Re: BEI Pier 91, EPA I.D. No. WAD 00081 2917
Pier 91 RCRA Facility Investigation

EPA COMMENTS ON OUTSTANDING
PIER 91 RFI ISSUES

FIGURE 1

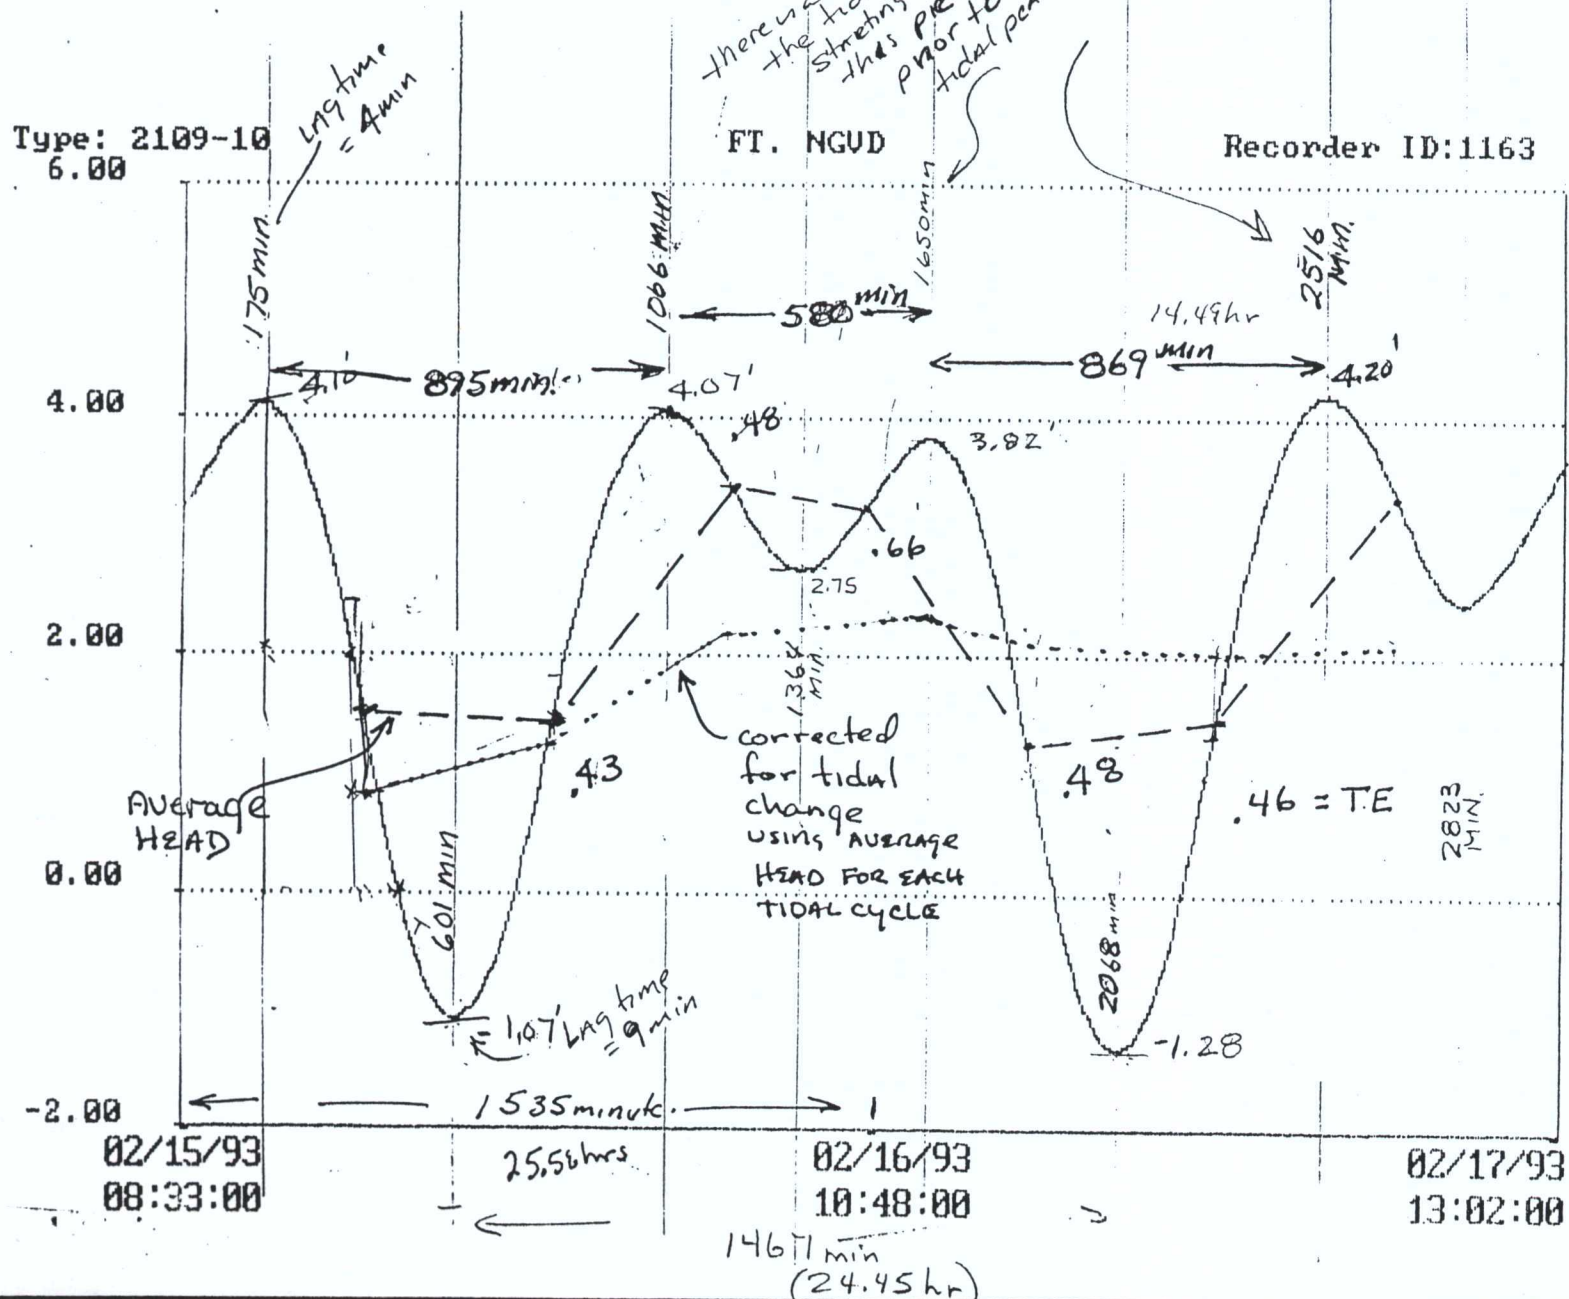
Further evidence of natural variation in tidal efficiencies is evident during a pump test at this same site. Well 26-50 was used as an observation well during a 72 hour pump test that covered 4 tidal cycles. No response occurred during the pump

test that was attributable to the pumping. During the test the TE of well 26-50 ranged from .43 to .66 (compared to .48 and .50 earlier).

The hydrograph of the average heads of well 26-50 in the well still indicate influence of the tides which are not consistent from one cycle to another. To demonstrate this inconsistency, the average heads in the well were adjusted to account for the range in the average waterway elevation from a datum of 0 feet elevation using the TE that was determined. The resulting curve (see figure) shows the residual change in water elevation in well 26-50 through the monitoring period. The time between peaks varies significantly between the different figures and during each monitoring period. On figure 3.14 the time between peaks is 810 minutes, while on the second figure, the time between peaks varies from 580 minutes to 895 minutes.
